Major Permit to Alter Case Report

Filing Date: August 12, 2015
Case No.: 2015-008484PTA
Project Address: 856 MARKET STREET
Conservation District: Kearny-Market-Mason-Sutter
Building Category: Category V (Unrated)
Zoning: C-3-R (Downtown Retail) District
80-130-F Height and Bulk District
Block/Lot: 0329 / 004
Applicant: Chuck Bloszies
228 Grant Avenue, 6th Floor
San Francisco, CA 94108
Staff Contact: Pilar LaValley - (415) 575-9084
pilar.lavalley@sfgov.org
Reviewed By: Tim Frye - (415) 575-6822
tim.frye@sfgov.org

RE: **Meeting Notes from Review and Comment at the
December 2 ARC-HPC Hearing for 856 Market Street**

856 MARKET
PROPOSED ELEVATION

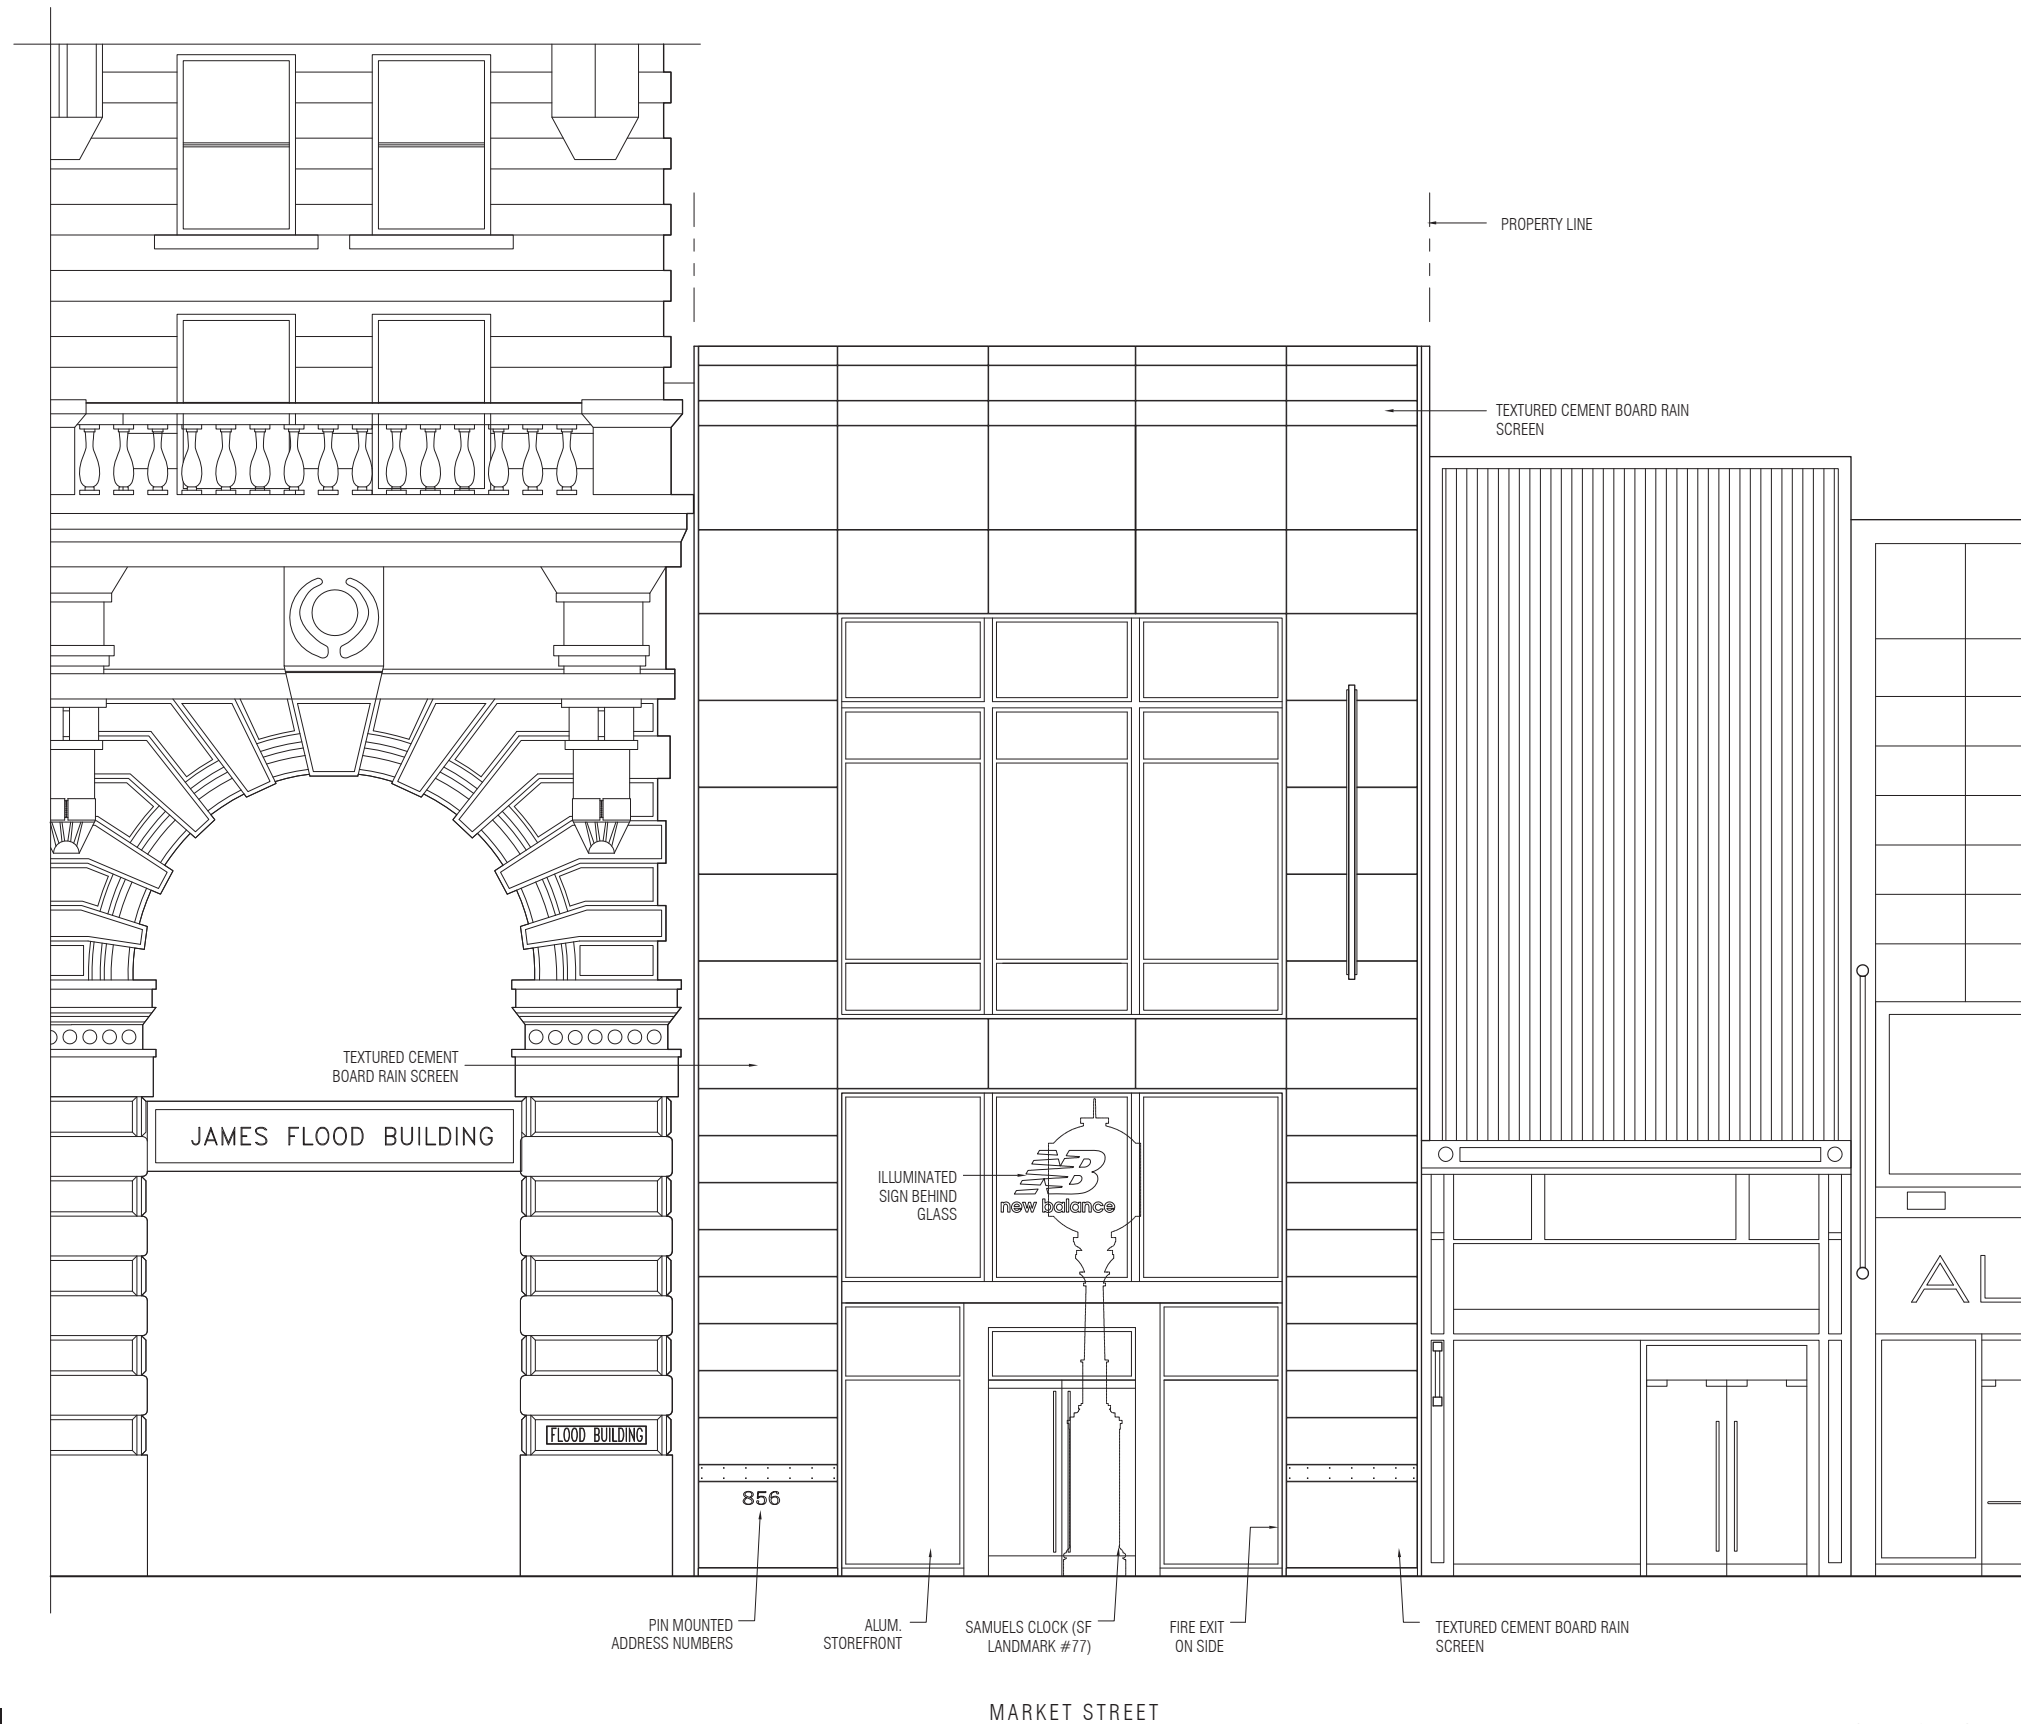
- 1. Composition and Massing:** The Commissioners concurred with staff that the configuration of the new fenestration and cladding would introduce a two-part vertical composition of the façade that appears compatible with the surrounding District and in conformance with Article 11. However, the Commissioners also noted that the façade design was too flat and recommended increasing the setback of the windows to a minimum of 6 inches with the solid horizontal band remaining in plane with the solid wall.

- The Commissioners recommended introducing a bevel, or similar slightly projecting footing element, at the transition between the textured and smooth panels at the lower portion of the building piers. This would add to the sense of weight and permanence at the building base as well as provide an additional change in plane on the façade.

3. **Detailing and Ornamentation:** The Commissioners concurred with staff that the simple and contemporary design of the façade appears compatible with the District. Commissioner Pearlman noted, and Commissioner Wolfram agreed that the change in color/texture at the top of the façade was too wide and made the building seem top-heavy; the proportions of the façade should be balanced.

DETAILS

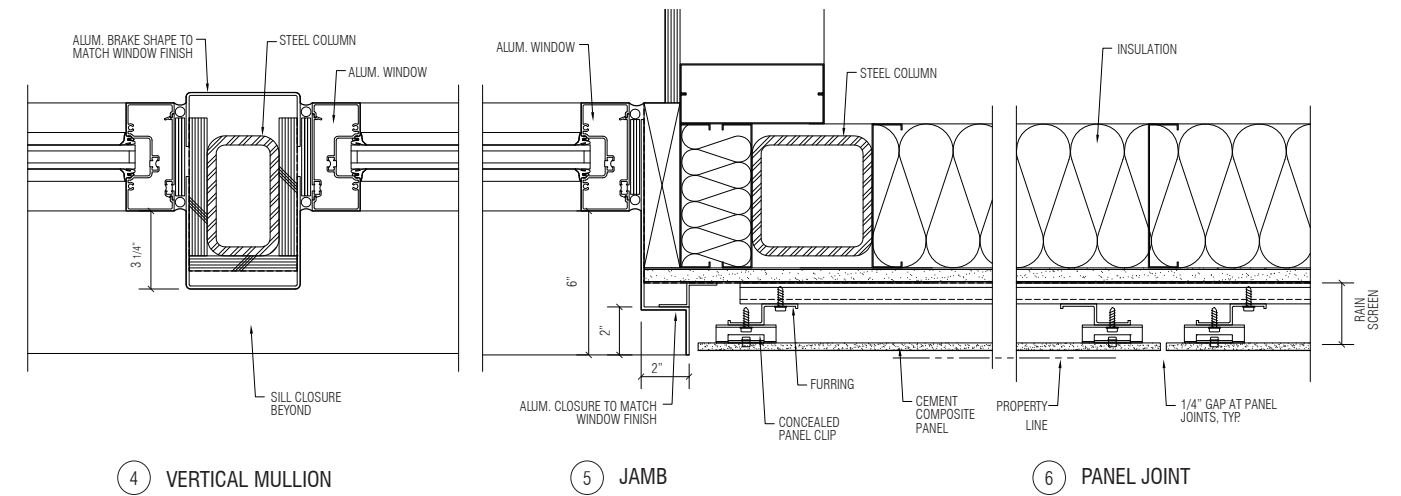
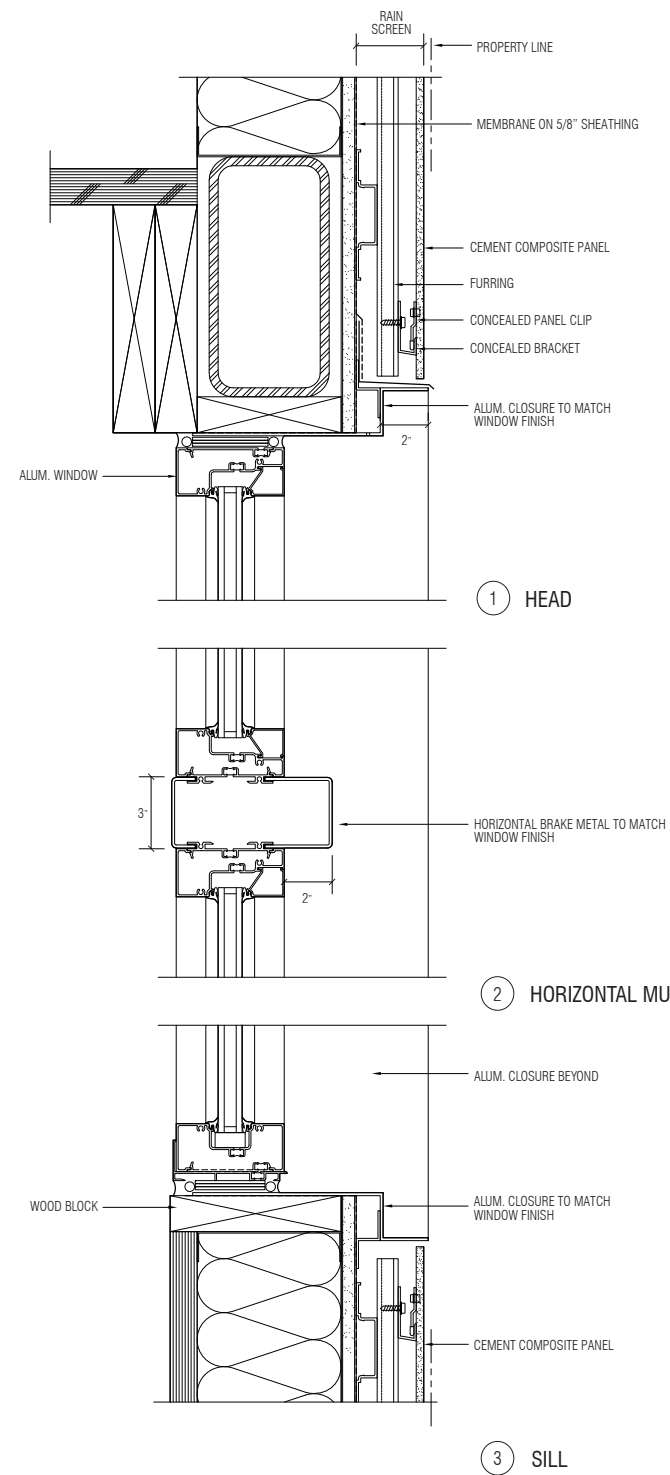
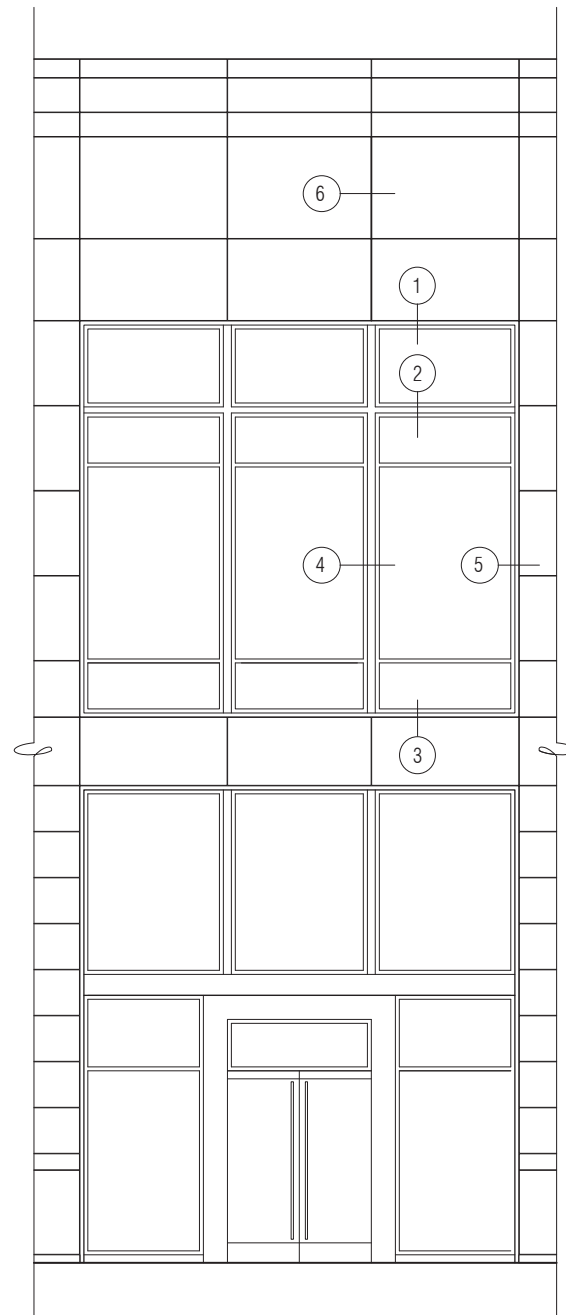
The Commissioners were comfortable with use of the proposed Swiss Pearl cement board panels but noted that the following modifications to the design were necessary for the material to be installed and detailed in a manner that appropriately references cladding materials typical of the District:

- The cement board panel cladding system should be installed on concealed fasteners.
 - The project sponsor should provide staff with examples of the Swiss Pearl installed in various locations and information about the material's overall performance in the field.

- The cement board panel cladding system should not return at the storefront or window insets as it is important to have a solid corner. Instead there should be a projecting steel (or similar) frame around the openings that the cement panel system relates to in order to create a sense of weight and mass. The Commissioners were concerned that the cladding materials not look too thin.

1. *That a mock-up of the cement board panel cladding will be installed for Preservation staff review and approval. The mock-up should be off sufficient size to demonstrate the installation mechanism, typical joints, and corner detail at storefront recess.*

SIGNS

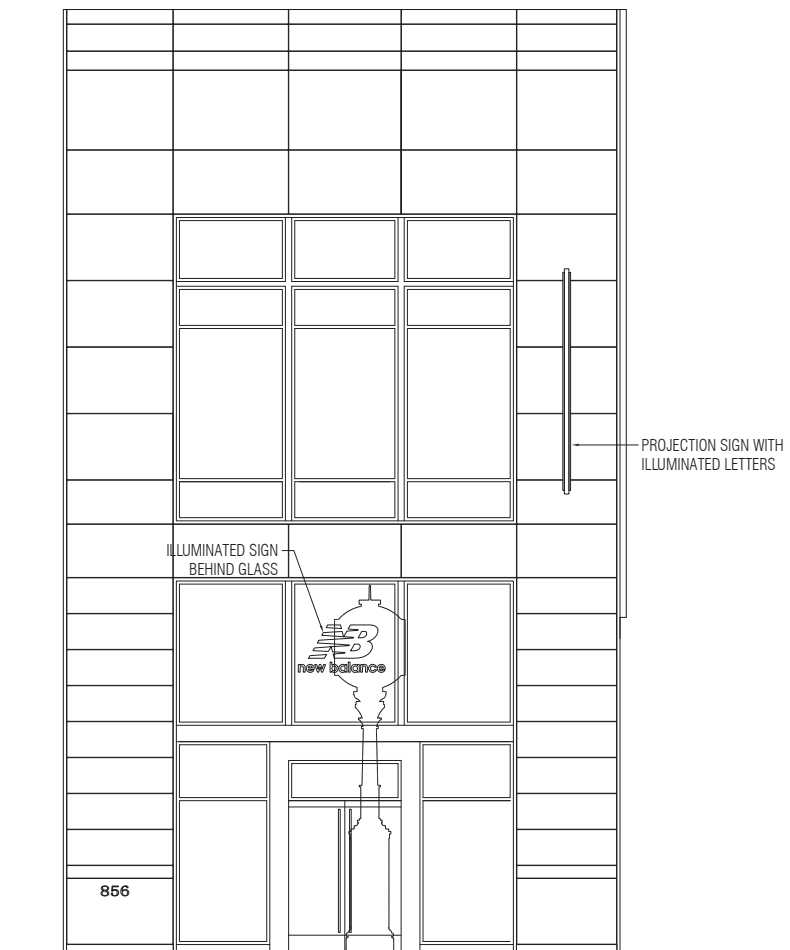
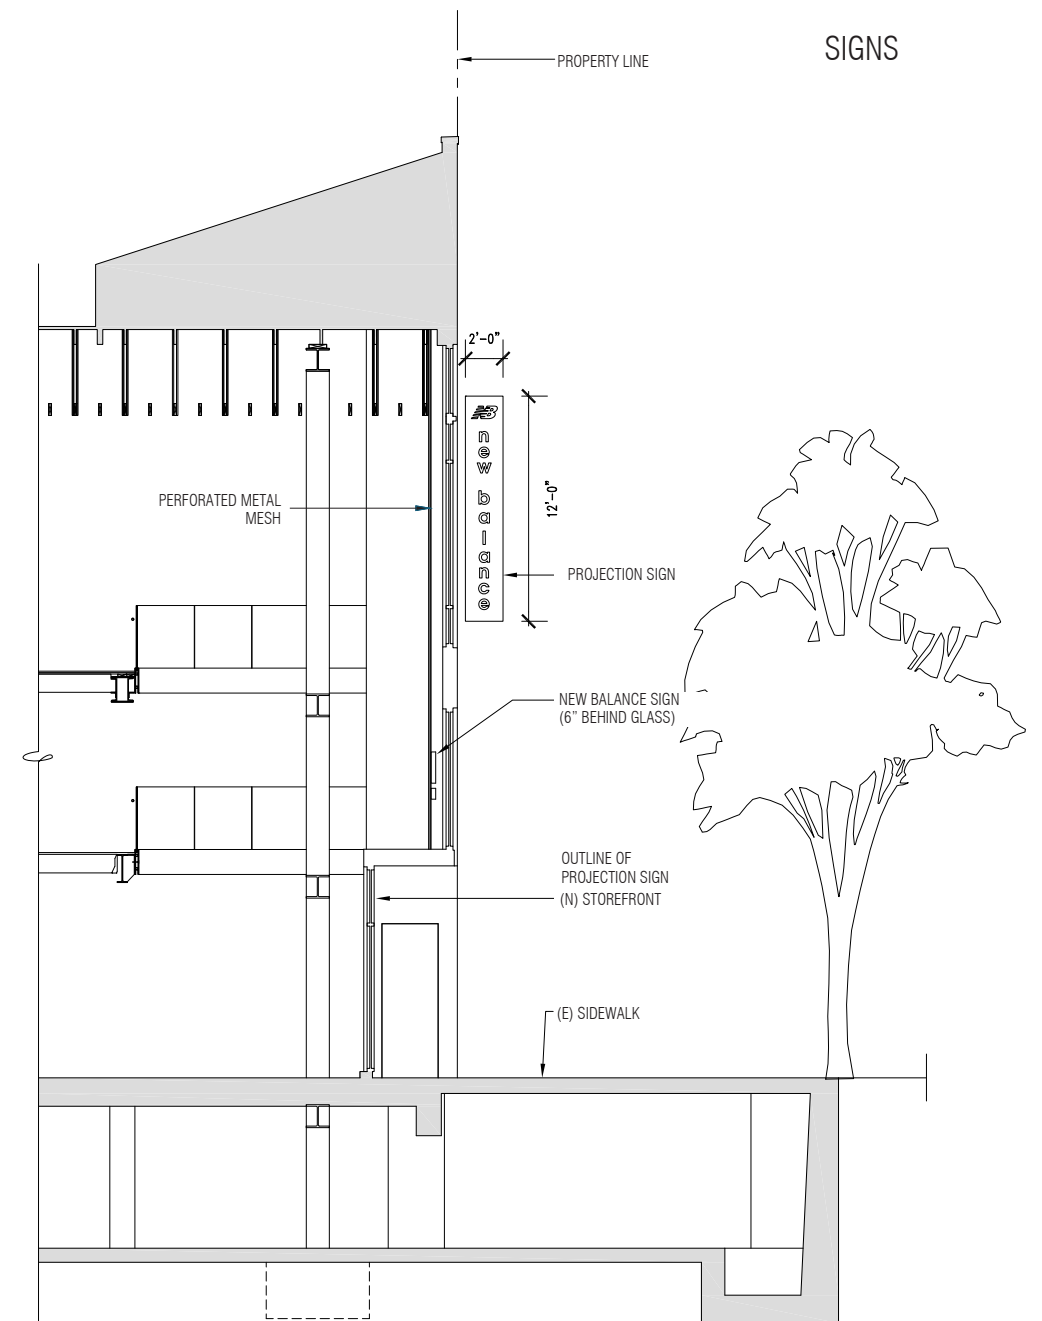
The wall sign is proposed to be installed 6 inches behind the window glazing in the center panel of the lower window. The sign would consist of internally illuminated channel letters and would be mounted to a perforated painted metal screen. The location and size of the proposed sign is appropriate, however, it should have halo-type illumination, or similar, for consistency with the Department's Sign Guidelines (draft). Therefore, staff recommends the following condition of approval:

2. *That the wall sign have a method of illumination that is consistent with the Department's Sign Guidelines (draft). This detail will be addressed during Preservation staff review and approval of the associated Sign Permit.*
